COMMUNITY MASTER PLAN

LEVEL B PLAN: AS APPROVED BY DEVELOPMENT REVIEW BOARD FEBRUARY 2008

AMENDED FEBRUARY 2024

Mesa del Sol

Figure 1-1

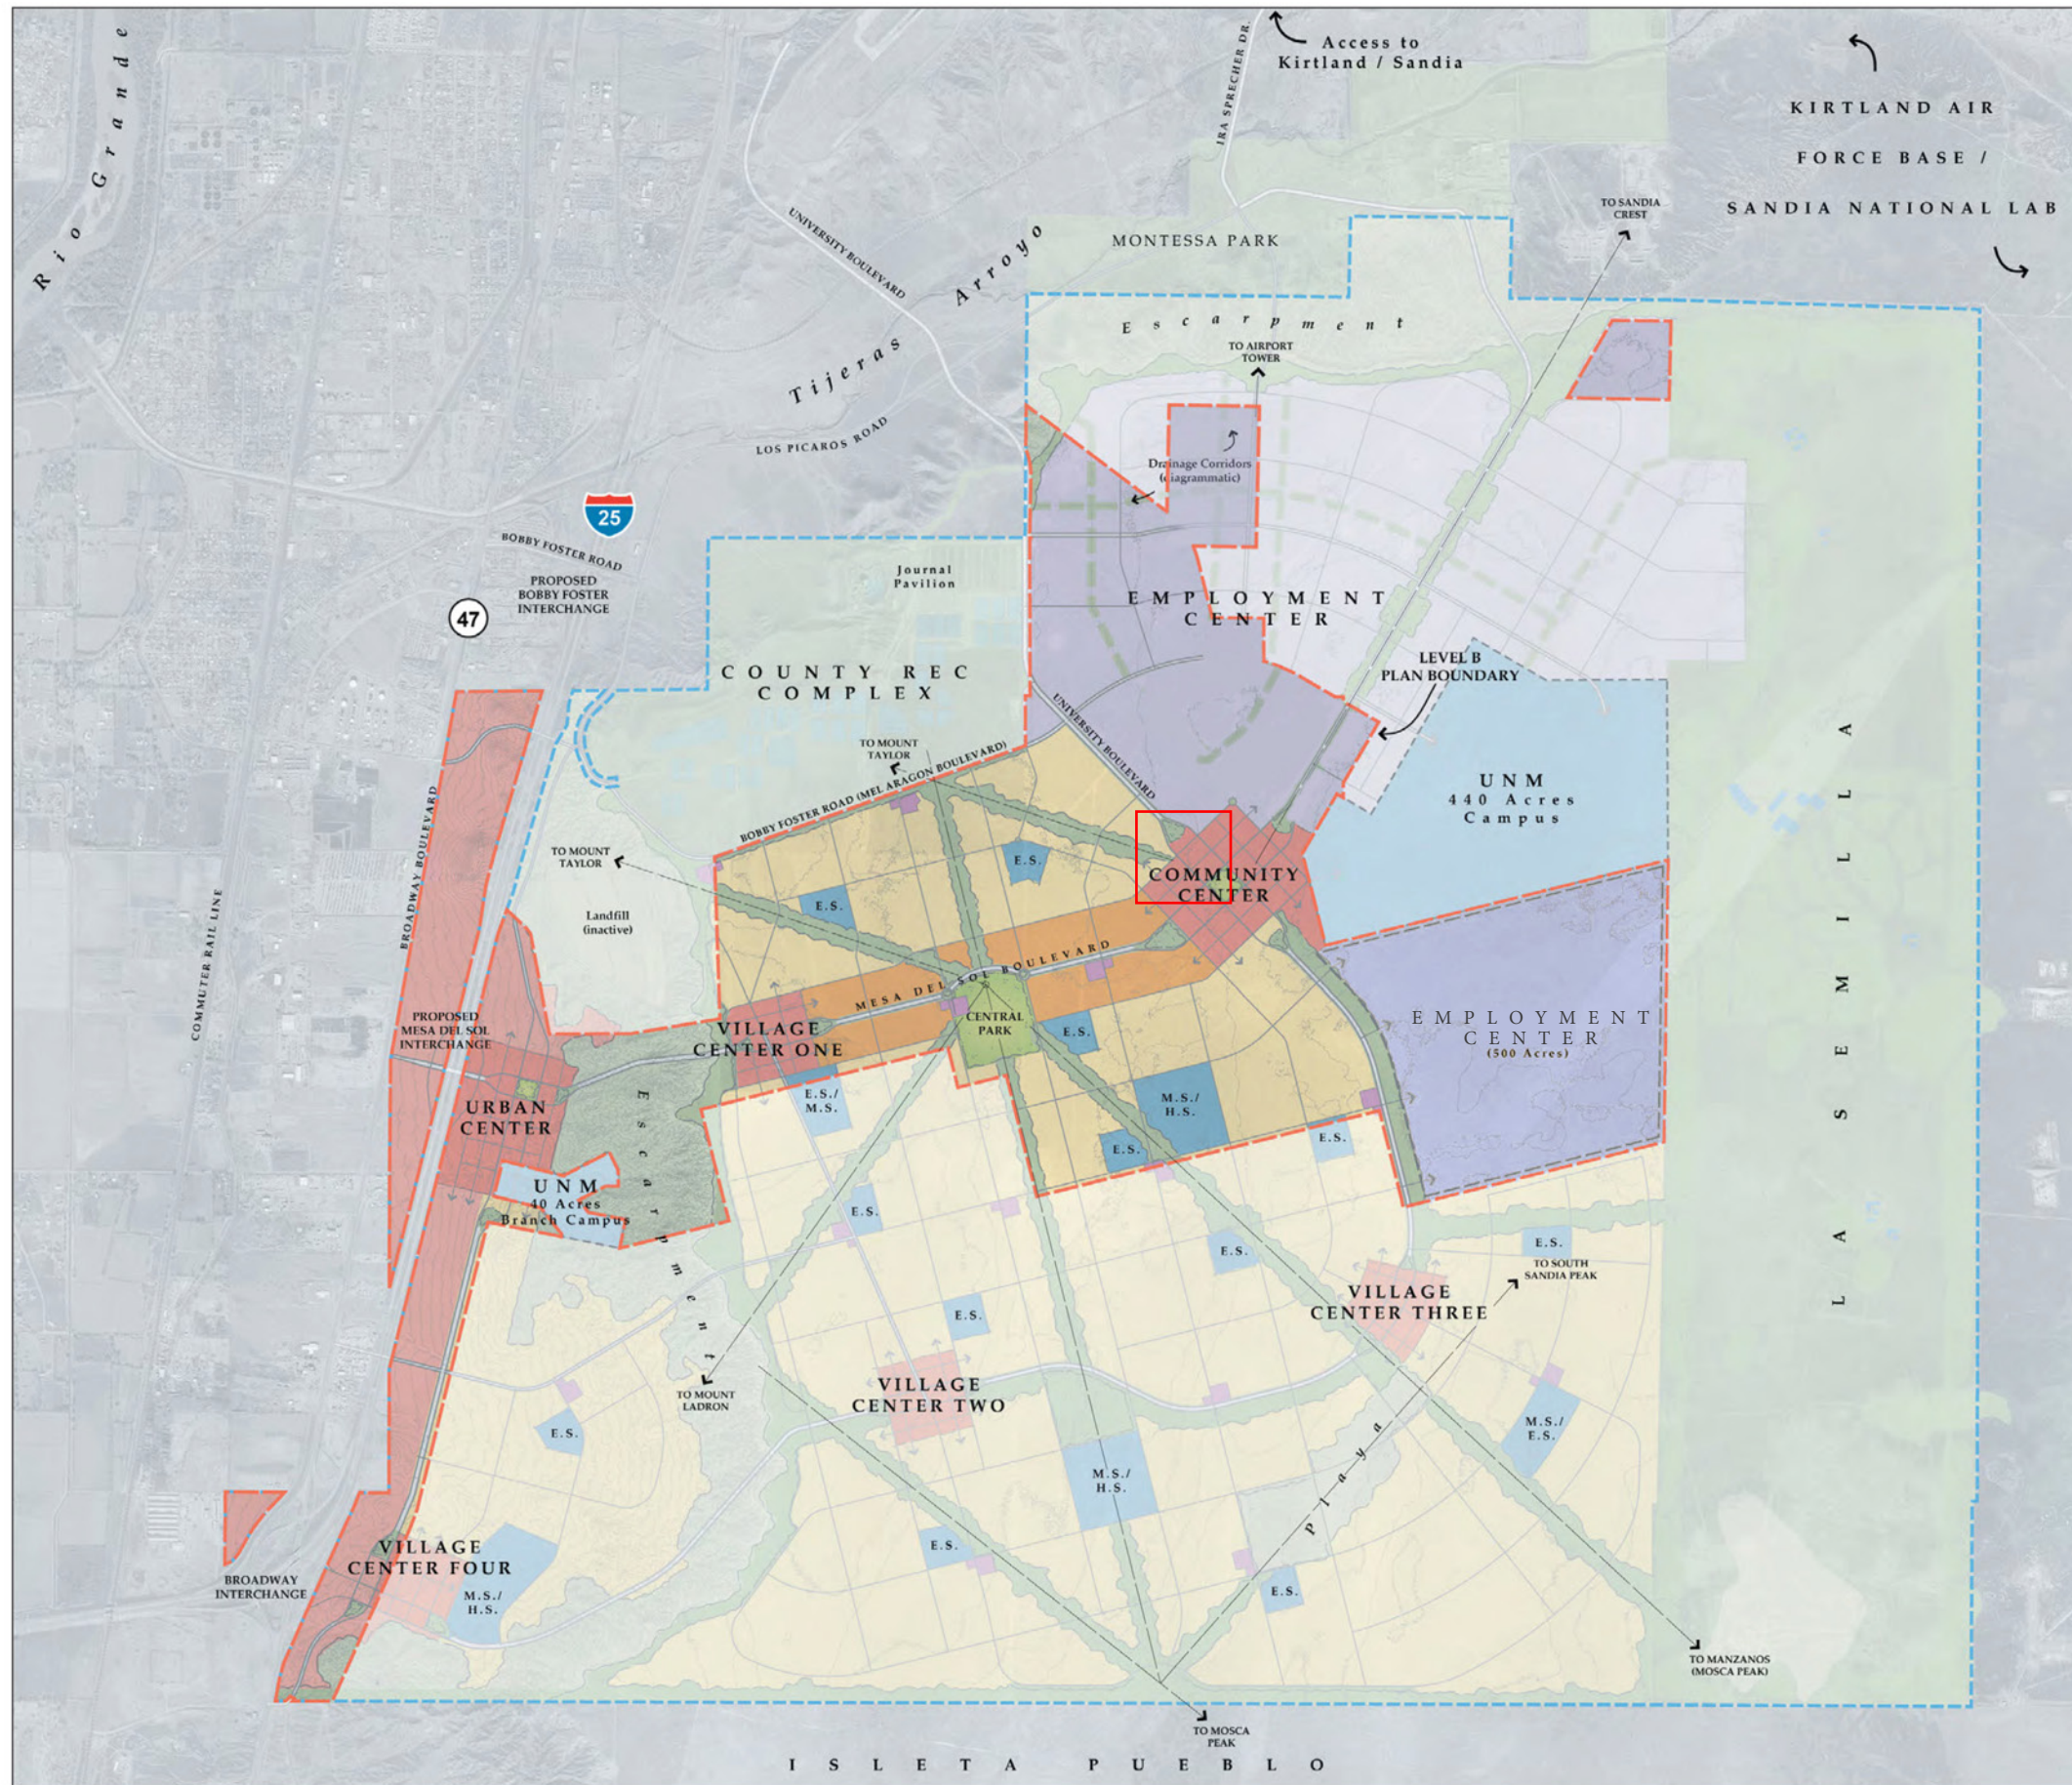
- Figure 1-1 updated to reflect Level B Plan Area modifications to remove / realign roadways and drainage corridors based on new site plan configuration.

- Table 1-1 was updated to reflect changes in acreages of the Employment Center & Residential Villages
- Figure 1-1 base map was updated to reflect employment rather than residential

- Figure 1-1 district boundary change for 1.2 acres: moving Tract A, Plat of Mesa Del Sol Montage Unite 3A, from the residential Villages to the Community Center land use district

Revised August 2021 - modifications to roadways and linear parks/drainage corridors within a southern portion of the Employment Center, as shown.

Revised August 2022 - district boundary change for 1.2 acres: moving Tract A, Plat of Mesa Del Sol Montage Unite 3A, from the Residential Villages to the Community Center land use district.

Figure 2-2

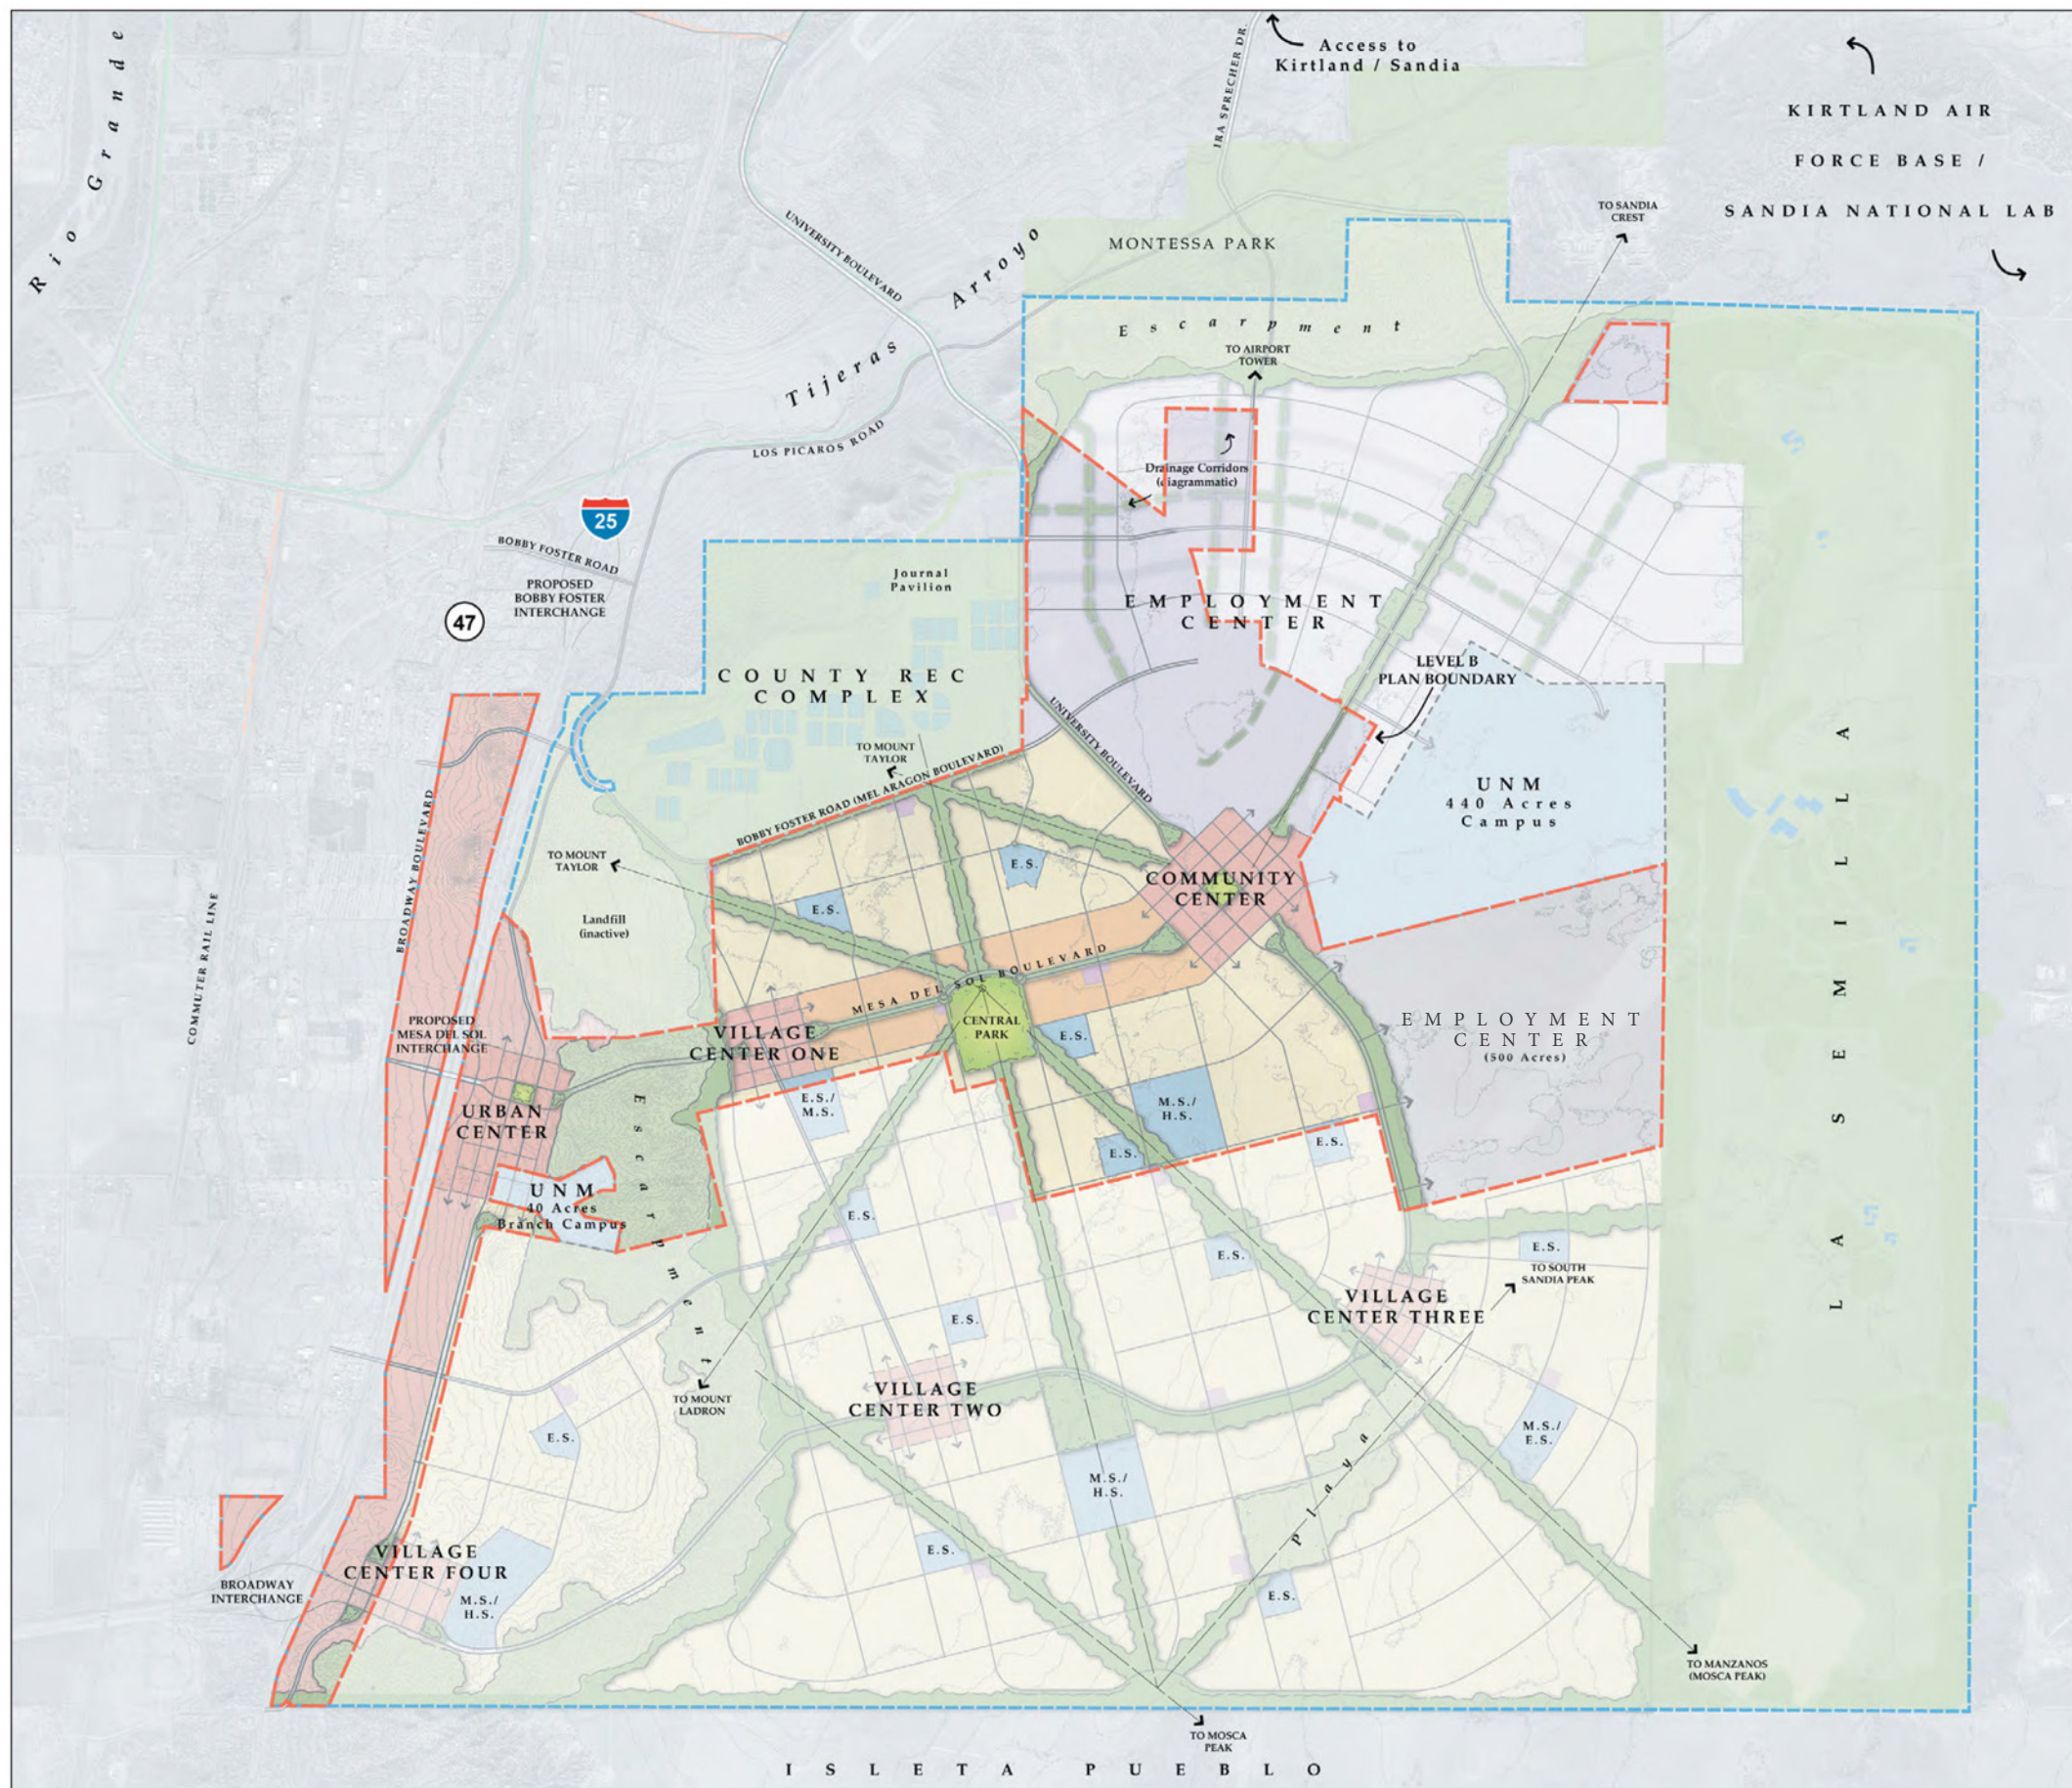
- Figure 2-2 updated to reflect changes to Major Urban Parks, Linear Park Corridors and Major Public Open Space exhibit to remove /realign roadways and linear park / drainage corridors.

- Section 2.4.1 language was updated to amend text to speak to the integration of active adult communities into the greater residential villages.
- Figure 2-2 base map was updated to reflect employment rather than residential
